RE: Ceja Vista Unit 1A, 1B, 1C, 2A, 2B, & C
Amended Drainage Management Plan
Stamp Date: 04/24/18
Hydrology File: P09D002E

PO Box 1293 Based upon the information provided in your resubmittal received 04/25/18, the Amended
Drainage Management Plan is approved for action by the DRB on the Preliminary Plat.

**Re: Ceja Vista Unit 1A, 1B, 1C, 2A, 2B, 3
Amended Drainage Management Plan
Engineers stamp date 4-18-18 (P09 / D002E)**

RE: Ceja Vista Unit 1A, 1B, 1C, 2A, 2B, & C
Amended Drainage Management Plan
Stamp Date: 03/30/18
Hydrology File: P09D002E

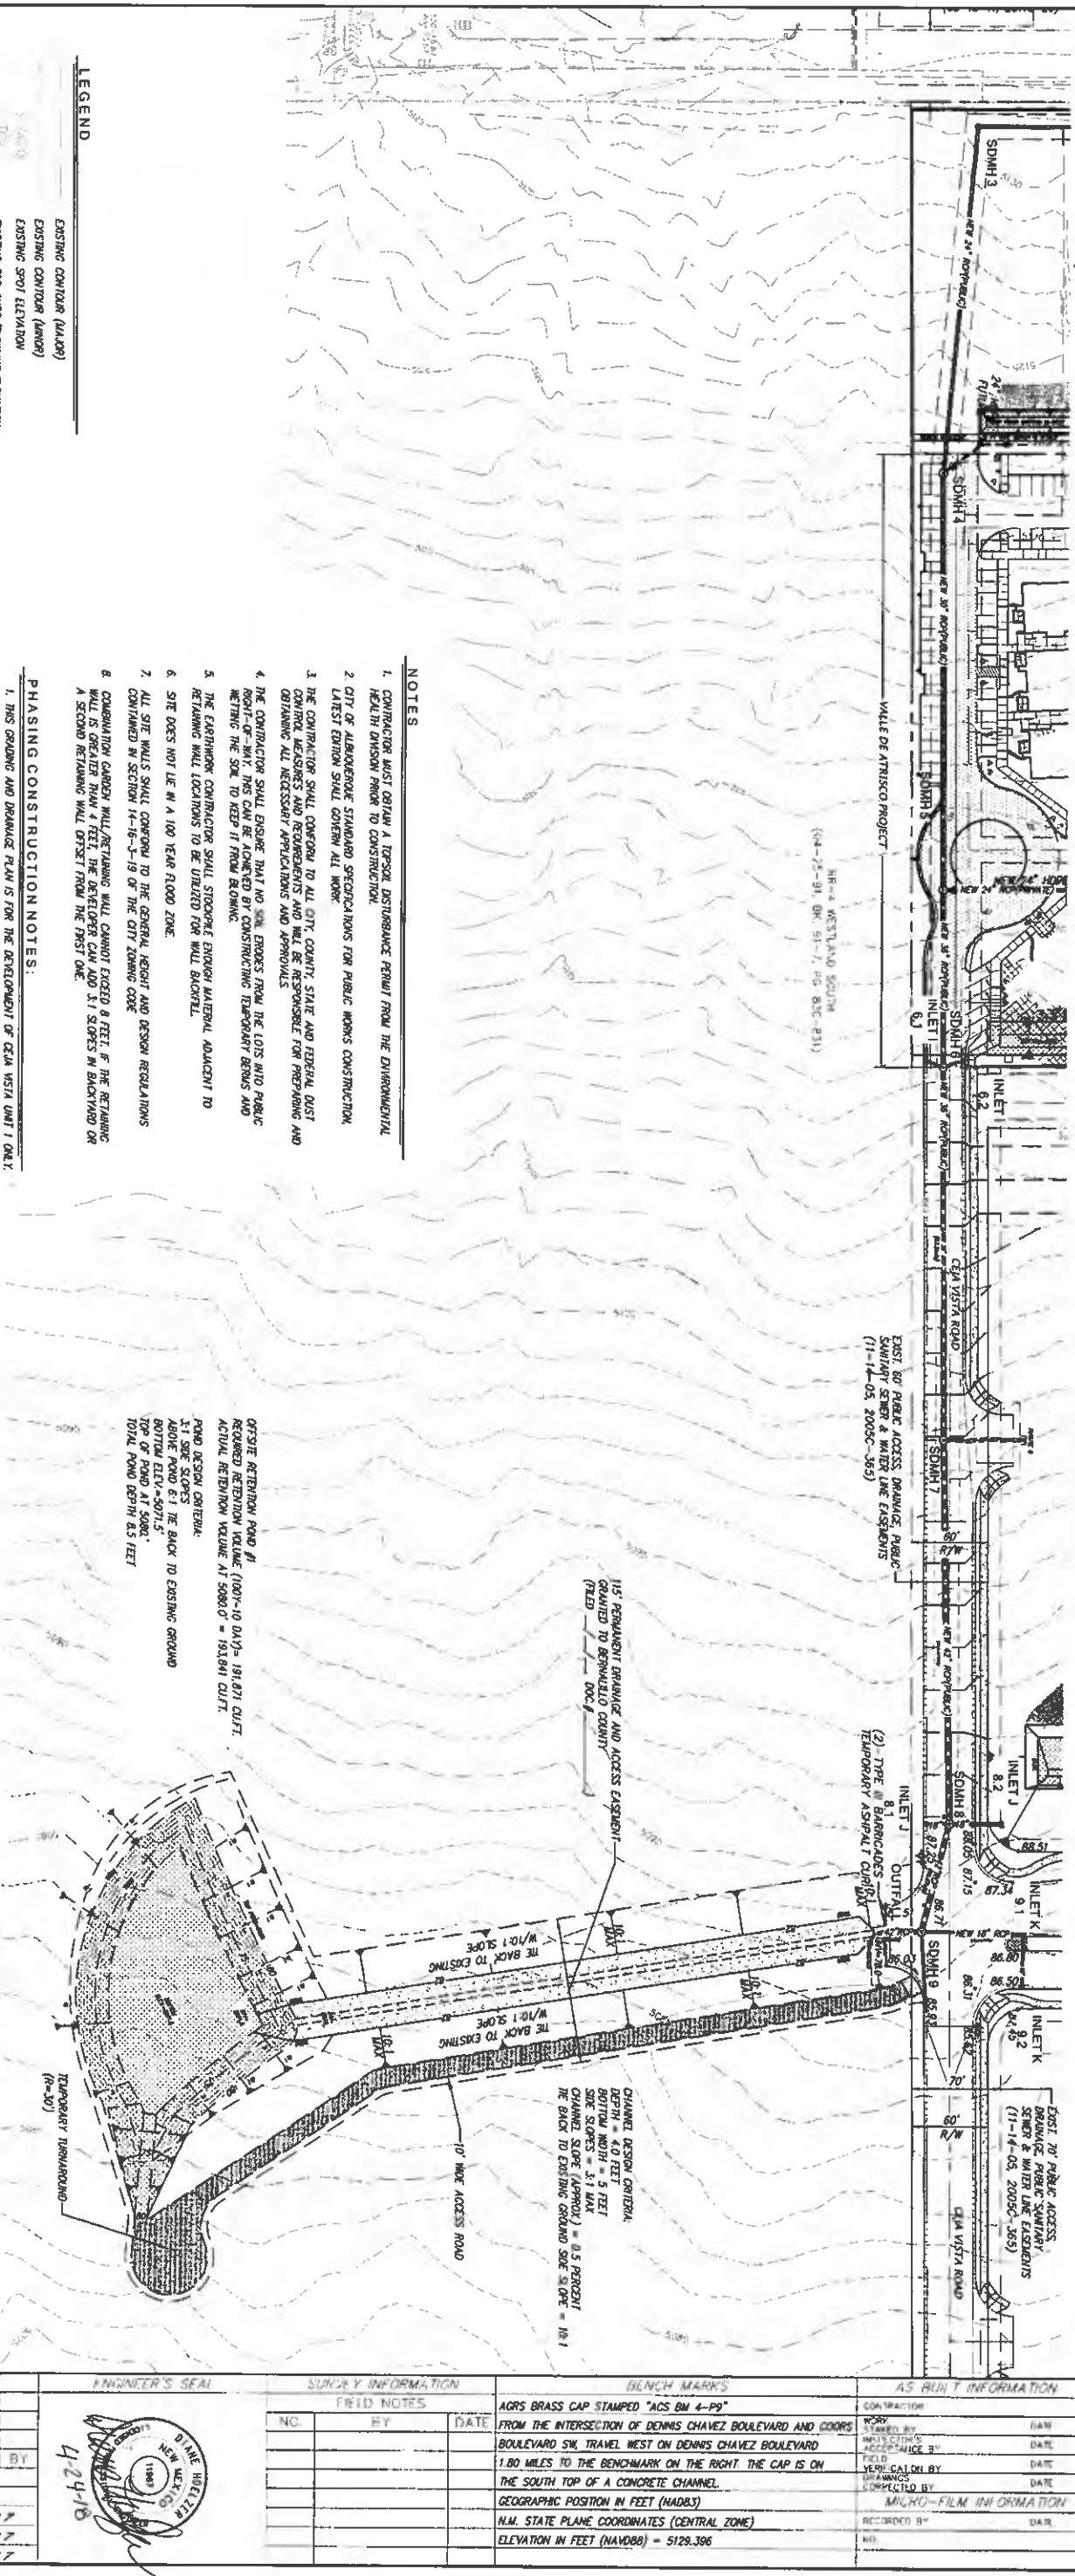
23. Grading and Drainage Plan Sheet 2. Please insure that under the Phasing Notes that each temporary pond is labeled and also which Tract they are located on.

24. Grading and Drainage Plan Sheet 2. The permanent drainage easement needs to be granted to the City of Albuquerque since this is receiving City public water and the City's required first flush volume for Tract RR-3-A-2. This easement can also be granted to the Bernalillo County if they also require it.

25. Grading and Drainage Plan Sheet 2. Please provide a section through the retention pond and spillway.
26. Grading and Drainage Plan Sheet 2. Please provide a detail of the spillway.

27. Grading and Drainage Plan Sheet 2. Per the DPM Chapter 22 Section 5.1, temporary retention ponds need to be sized based on the 100 year – 10 day storm event and not two (2) times the 100 year -6 hour storm event.

28. Grading and Drainage Plan Sheet 2. Offsite temporary retention pond must be sized for the Developed Conditions for all of Unit 1.

29. Grading and Drainage Plan Sheet 2. Please correct Phasing Note #6 to reflect comment #28.

23. Sheet 2 is only discussing Pond #1, the regional offsite pond. The temporary ponds are discussed and presented on sheet 1.
24. Understood. We will pursue this after amended preliminary plat approval.

25. Design details of the offsite pond will be presented during DRC review.
26. Spillway details will be presented during time of DRC review.
27. The offsite temporary pond size has been revised for the 100 year 10 day storm event volume. Table 2 presents the calculations of this volume.

28. The pond has been revised to accommodate the Unit 1 developed conditions.
29. All notes in Phasing Construction has been revised to accommodate revisions.

Dennis Chavez Southside Road Swale-West of 98th Street

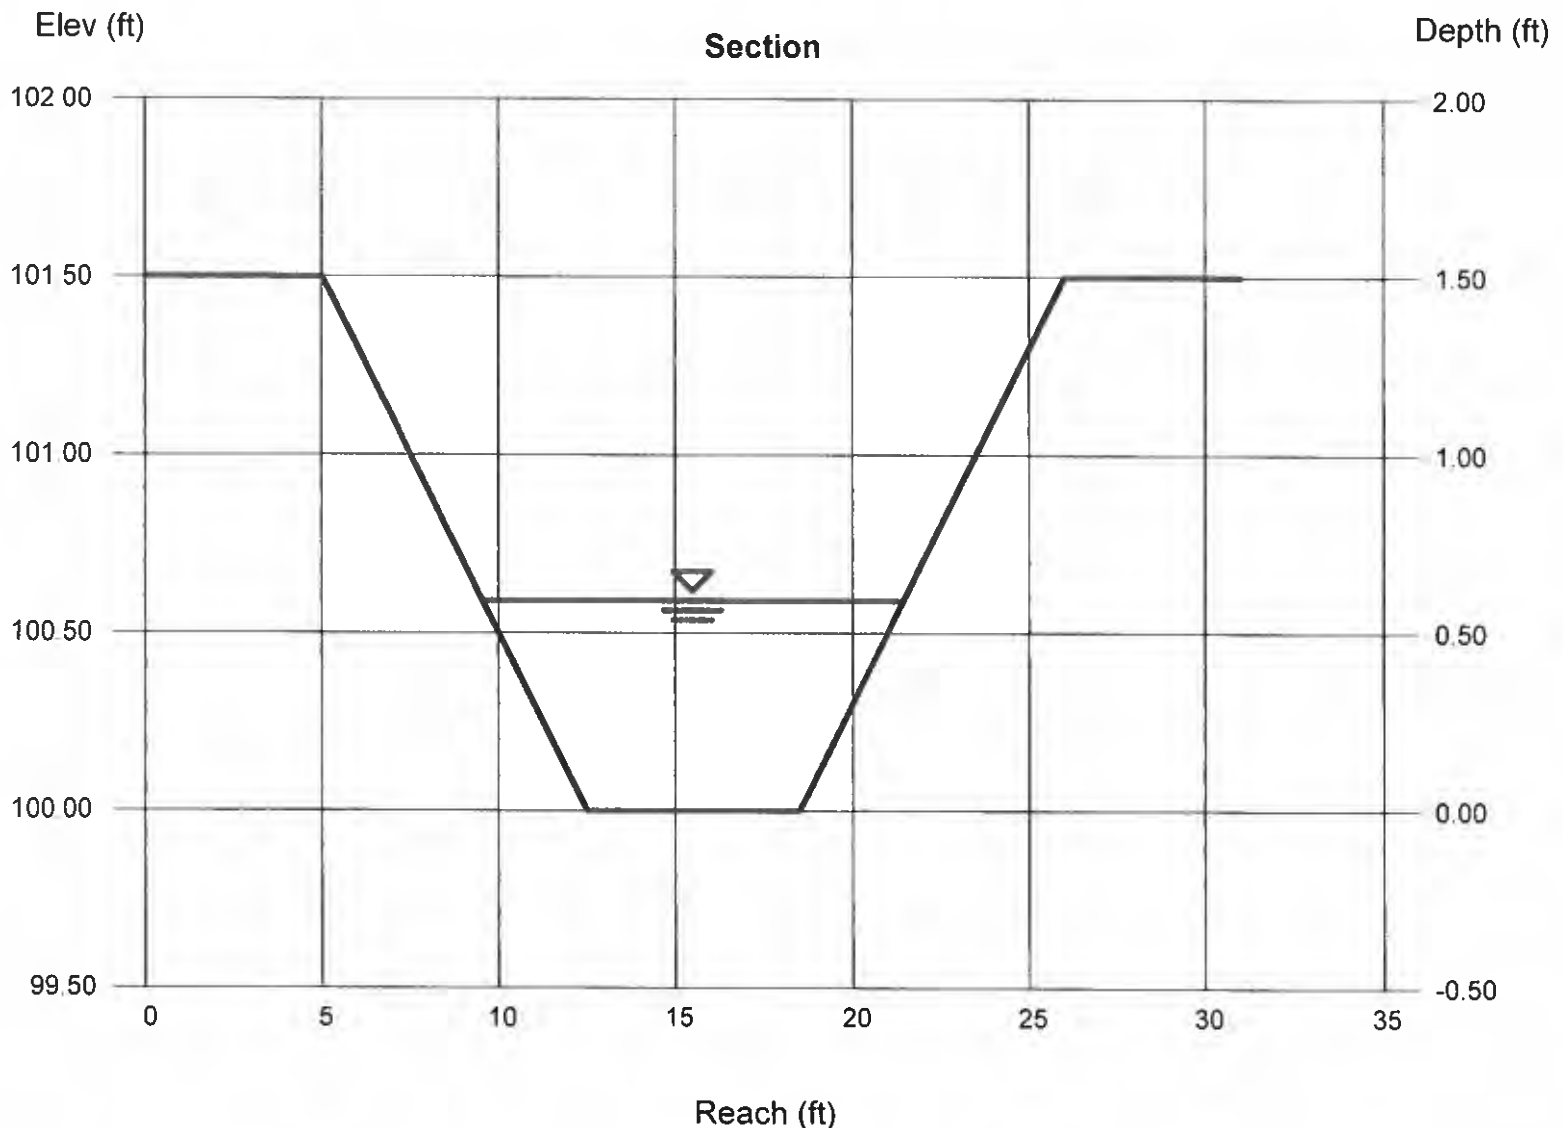
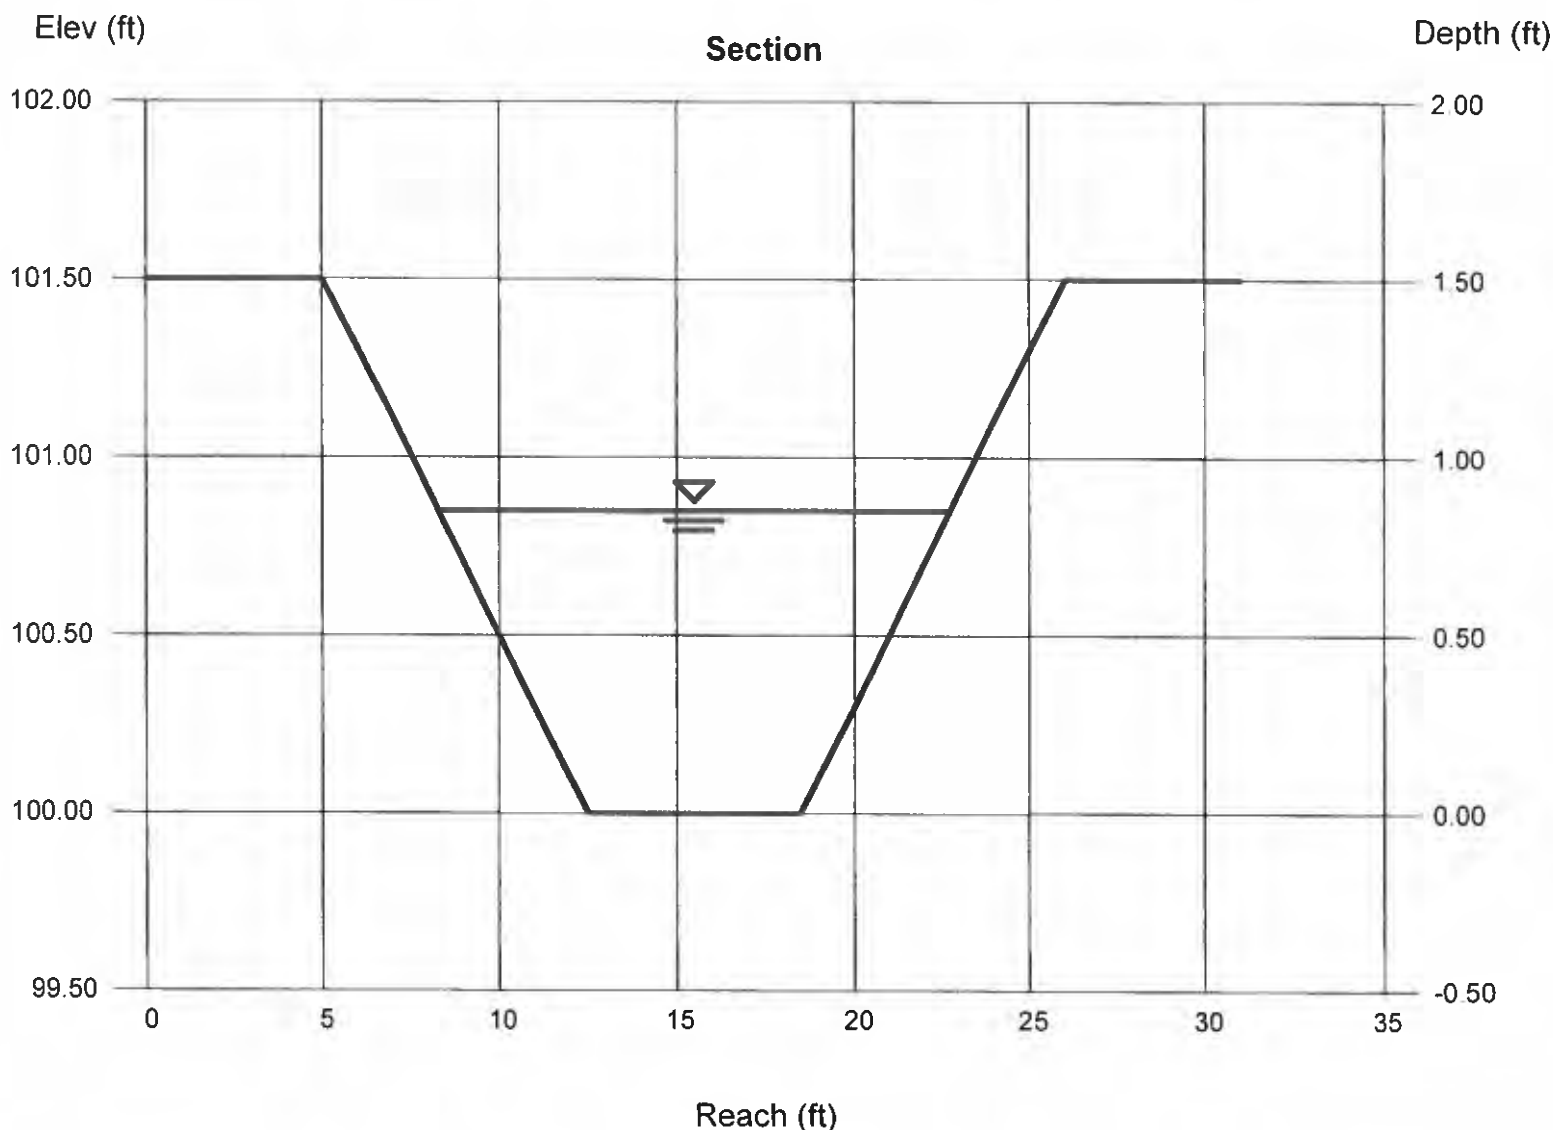
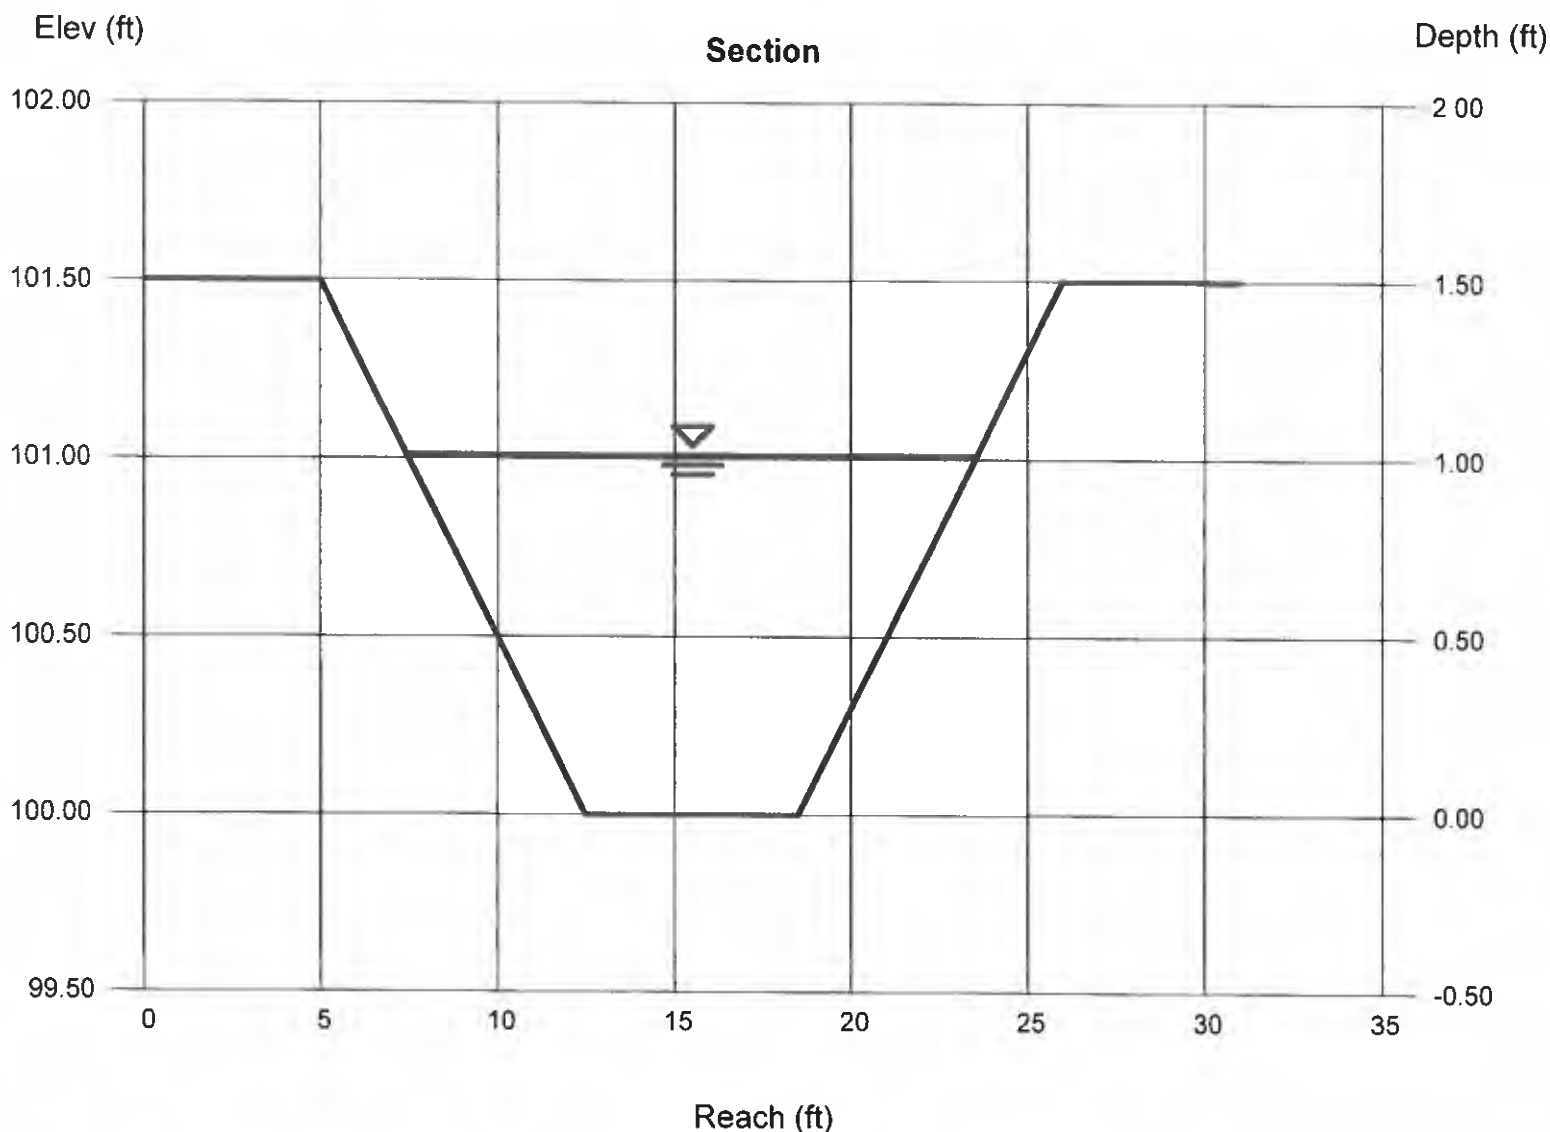
- NM 87103 1. Please provide a section along Dennis Chavez showing the proposed concrete
Channel per NMDOT's acceptance of the design. The trapezoidal section
calculations may need to be revised per the final design.
- www.cabq.gov 2. For the public drainage channel and temporary retention pond in Bernalillo
County, a Permanent Public Drainage Easement granted to the City of
Albuquerque and an Agreement and Covenant for said public drainage channel
and temporary retention pond will have to be recorded.
3. Please provide a Drainage Covenant per Chapter 17 of the DPM for each
temporary pond on Tract RR-3-A-1, RR-3-A-2, and RR-3-B. If the Grading and
Drainage Plans for the proposed development on Tract RR-3-A-2 is approved
before the recording of the Drainage Covenant, then the construction of the
temporary pond and therefore a Drainage Covenant are not needed for Tract RR-
3-A-2.

10. Amended Drainage Management Plan. Please provide the calculations for the offsite drainage channel to the south within Bernalillo County.
11. Grading and Drainage Plan. Please label both sheets as "Ceja Vista Unit 1, Grading and Drainage Plan".

- 9. These calculations are provided in the report and in a table on the grading and drainage plan.*
- 10. The Dennis Chavez swale summary reports have been included in the report.*
